# TOWNSVILLE OCEAN TERMINAL

# BREAKWATER COVE

5002/02  
R-KO0115- Rev 2  
July 2008

***IMPACTS ON MARITIME TRAFFIC***

OCEAN TERMINAL  
Townsville Breakwater  
Figure 1

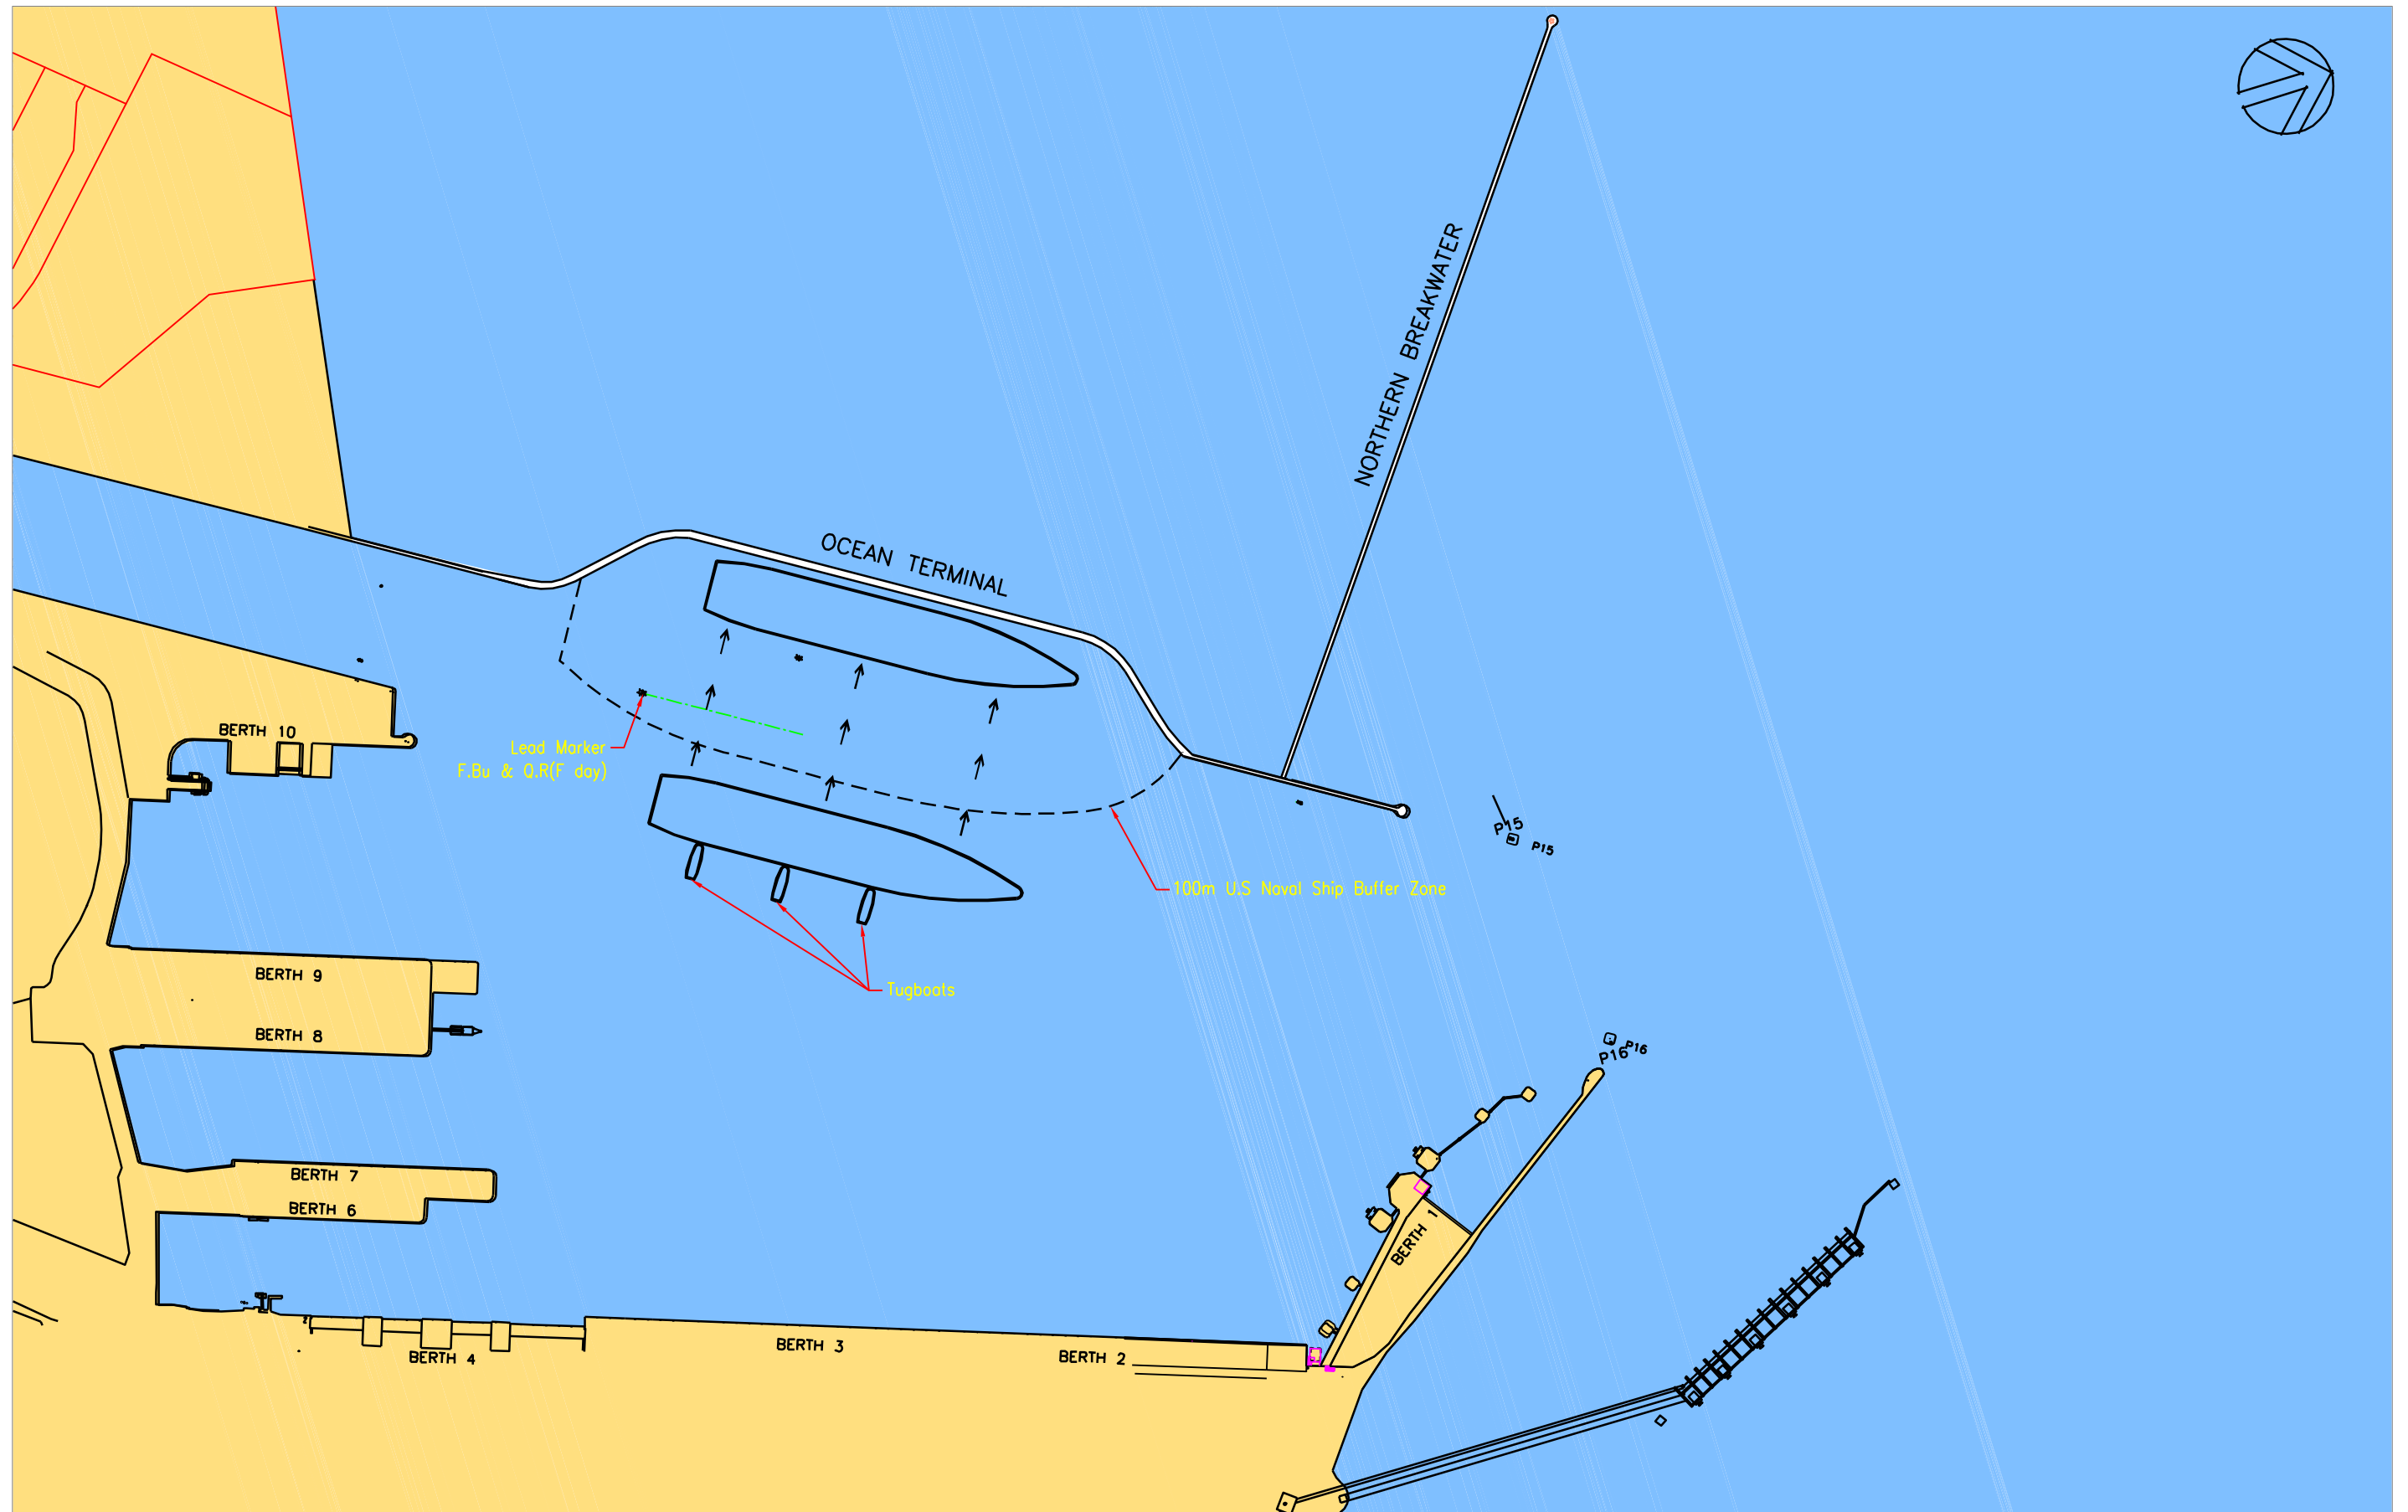
In response to concerns regarding potential conflict of cruise ship berthing with the beacon located towards the southern end of the berth, the Pilots advised that berthing operations will involve tugs pushing the boat into the berth and consequently relocation of this beacon would not be required.

**Figure 1: Ocean Terminal Berth** shows a 100m buffer line around a ship with a 300m length and 50m beam. Figure 1 demonstrates that recreational and commercial vessels can clear a berthed vessel berthed at the cruise ship terminal by at least 150m, although it would mean they would transgress into the Townsville Port Security Limit. The buffer zones for Naval ships are enforced by the presence of Water Police. As such, the transgression of recreational and commercial traffic into the Security Zone at police direction will not be problematic. It should also be noted that the level of commercial and recreational traffic is low as shown in Section 6.0 of this report.

The location of the beacon relative to the berth and the direction of berthing **is shown in Figure 1: Ocean Terminal Berth.**

EXISTING MARINA ACCESS  
(Metres AHD)  
Townsville Breakwater  
Figure 2

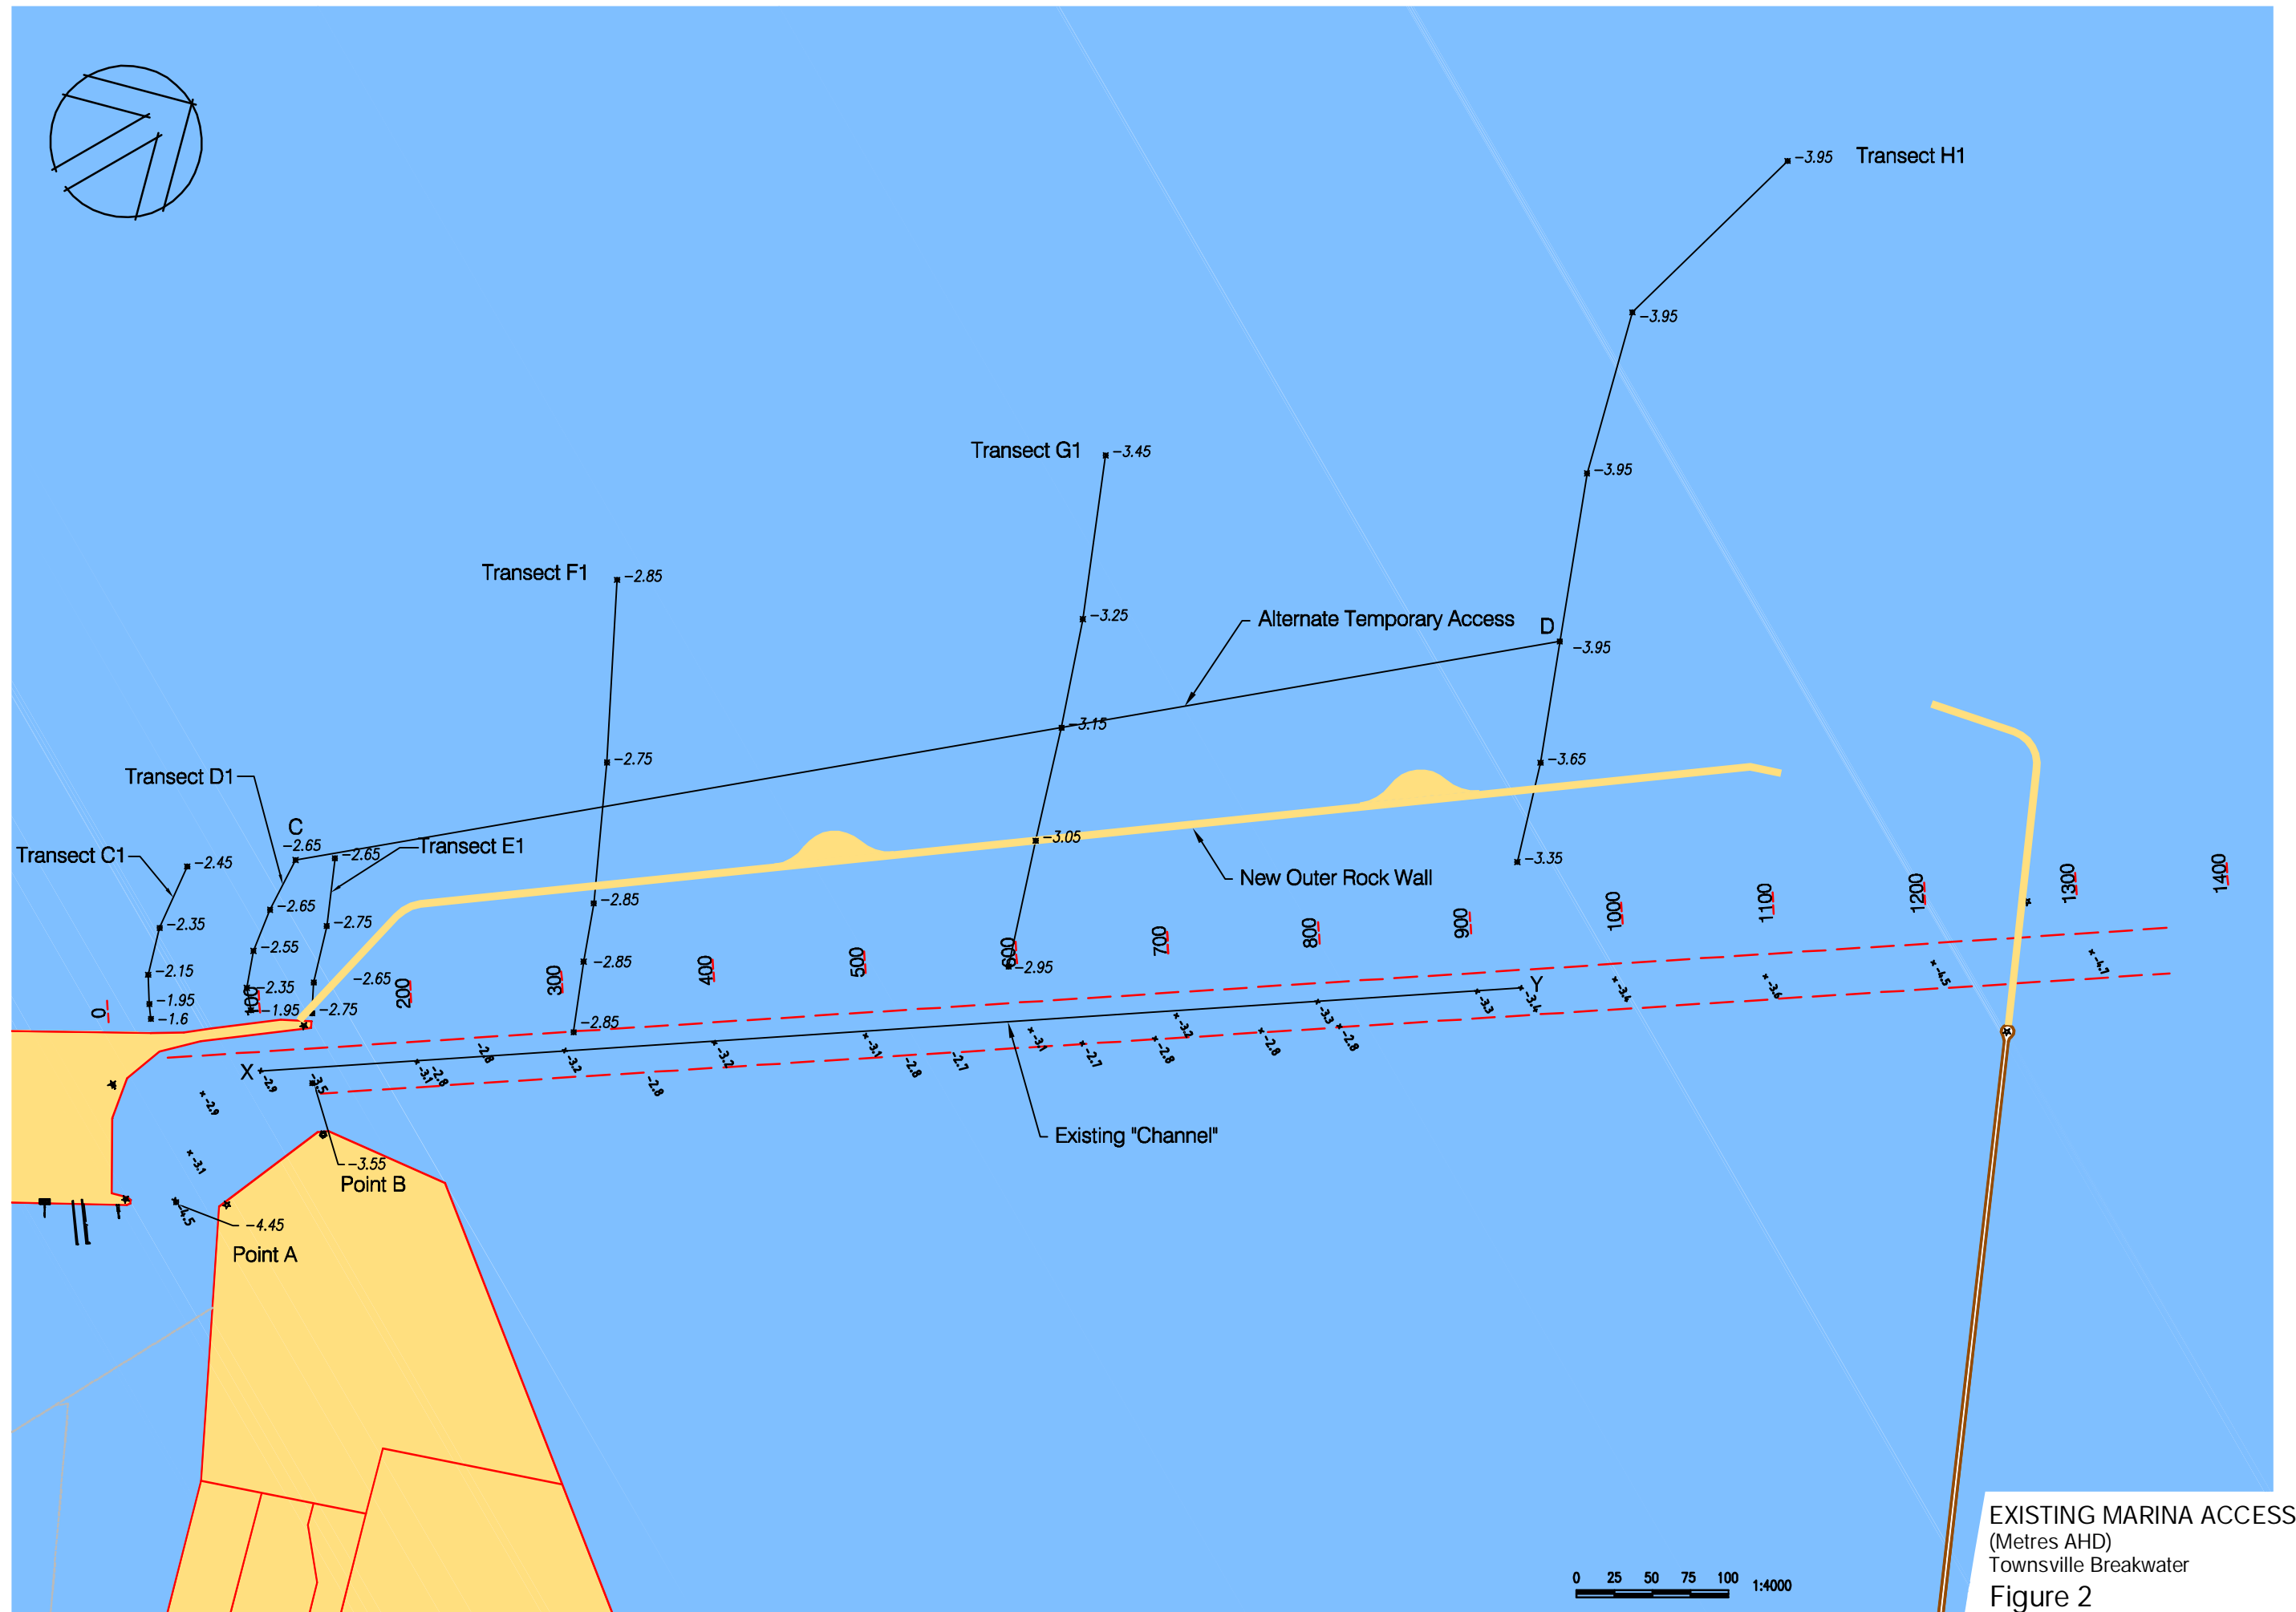
Access channel to existing marina will not be available during construction and this may limit access to larger vessels. A management strategy or creation of an alternative channel may be required to assure reasonable access.	5.0

Existing channel into breakwater marina will not be available during construction and there will be cumulative loss of utilisation of craft except in high part of tide.	5.0
	Construction site lighting is a possible source of interference with navigation lights.	3.0
	The development will result in increased demand for public boat launch facilities.	7.0

The survey data has been plotted on **Figure 2: Existing Marina Access** which shows a summary of data from the Brazier Motto survey (existing channel) and the FCG survey across the proposed temporary access route.

The proposed temporary access route has a slightly larger minimum depth as the existing access to the marina. As such, there is no reduced level of service to/from the current marina as a result of the proposed temporary access route.

Consequently there is no requirement for dredging of a temporary access channel to maintain the level of service to the existing marina during construction of the FDA.
